D1002504 TMS, SISKIYOU MOUNT BRACKET, LOWER OUTBOARD, PART PDM REV: X-014, DRAWING PDM REV: X-011

PART NAME		TMS, SISKIYOU MOUNT BRACKET, LOWER OUTBOARD	
DESIGNER	I. ROMERO	23 SEP 2010	SIZE DWG. NO.
DRAFTER	M. MILLER	25 APR 2011	B D1002504
CHECKER	k mailand	10-26-12	REV.
APPROVAL			v2
SCALE: NONE		PROJECTION:	
		SHEET 1 OF 2

SECTION A-A

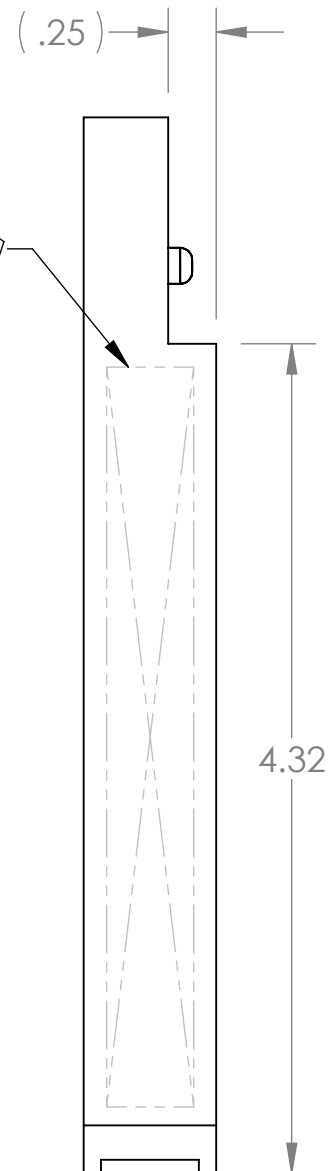
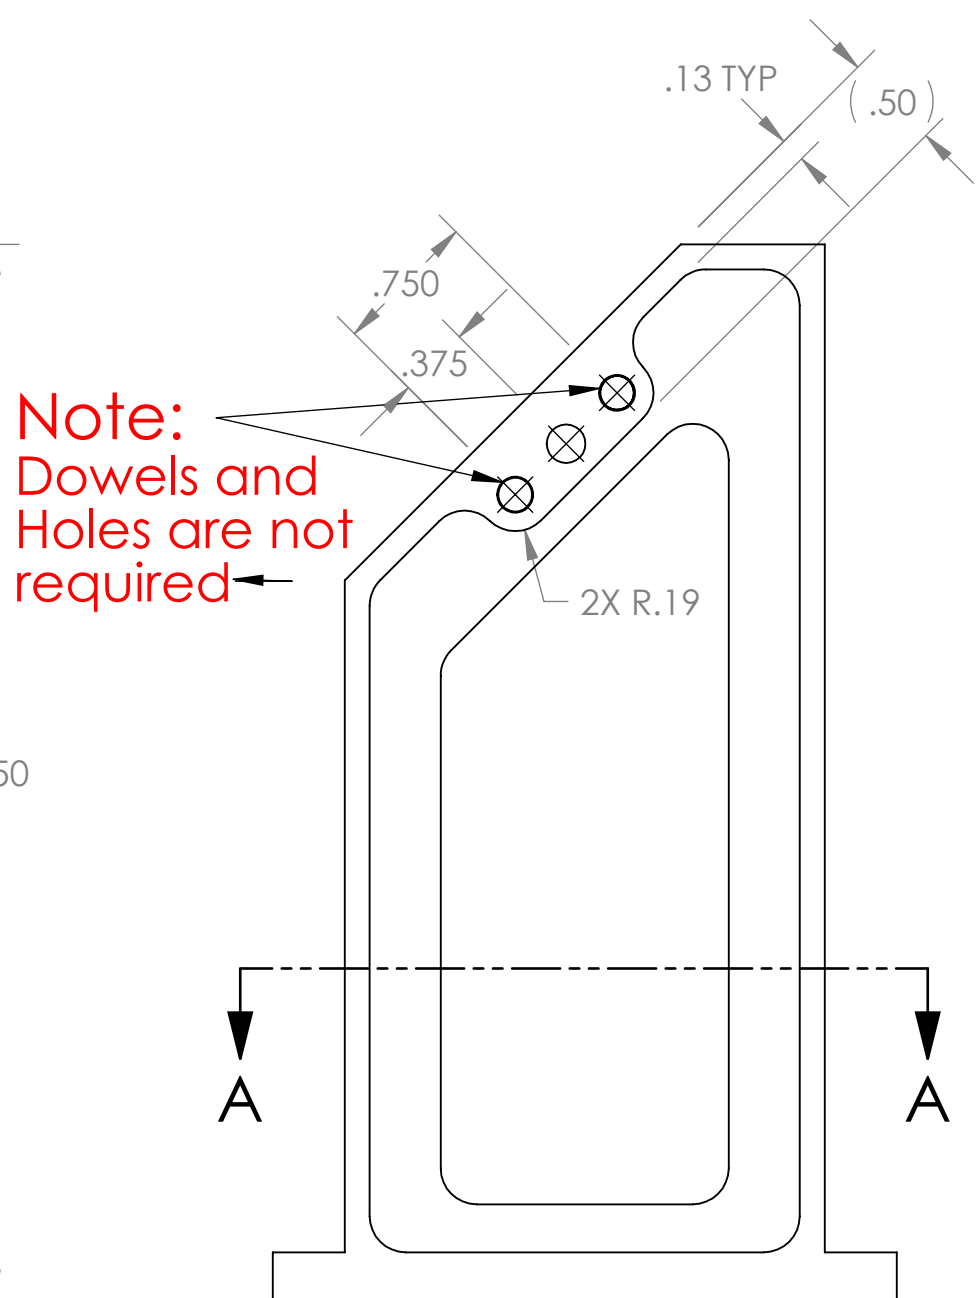
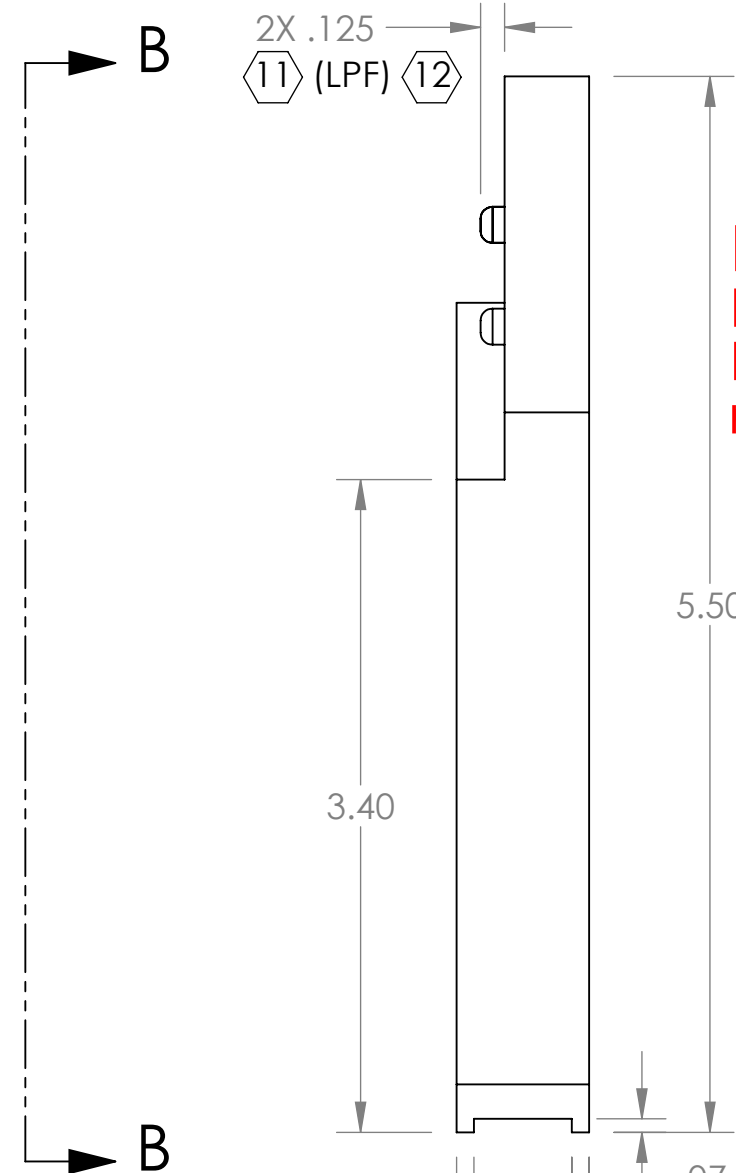
Note: Dowels and Holes are not required

VIEW B-B

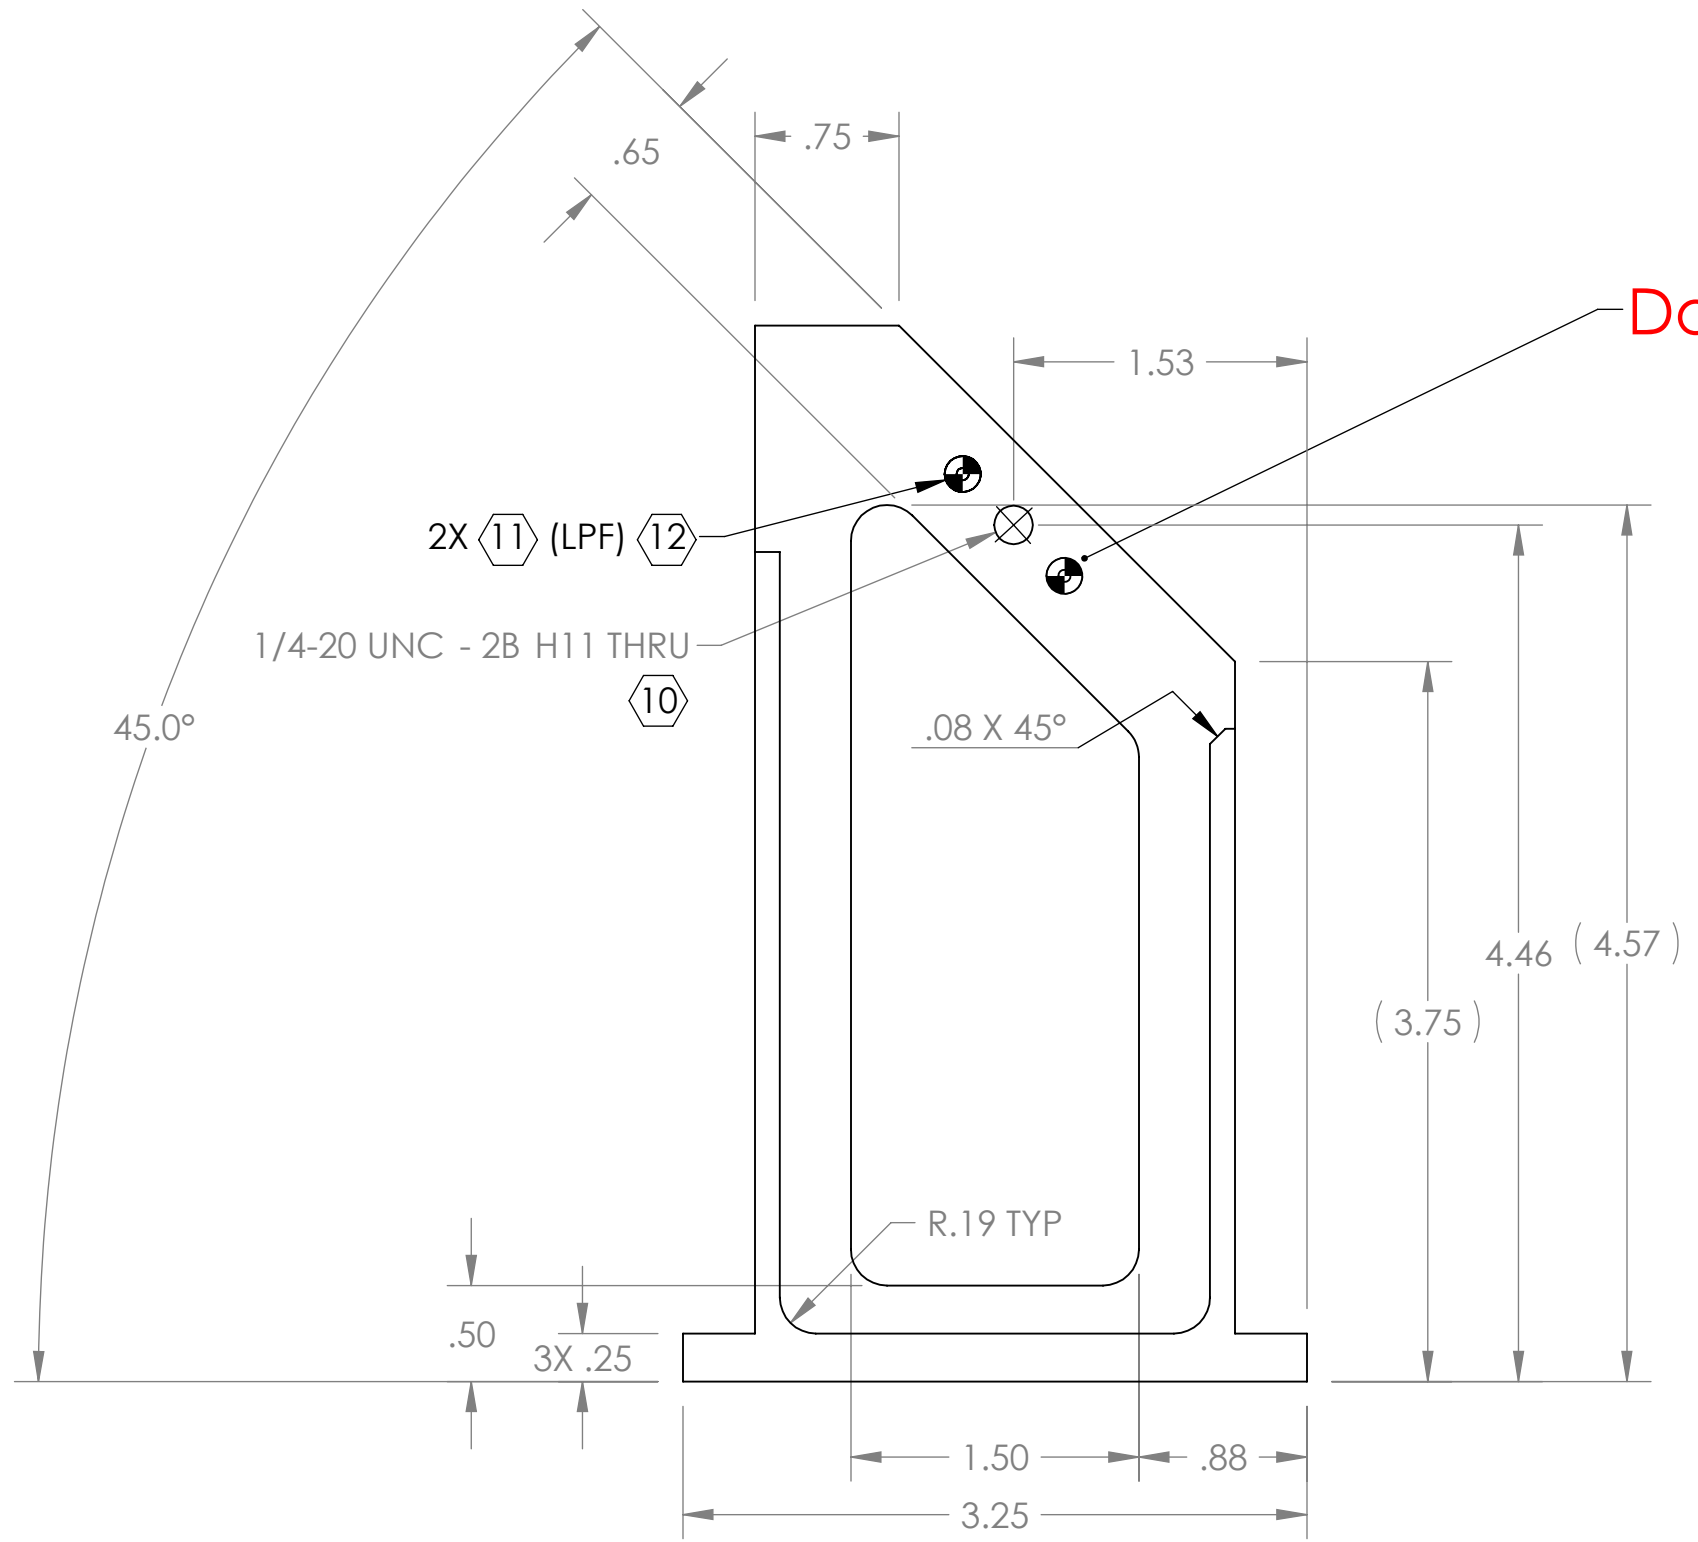
Dowel pins not required
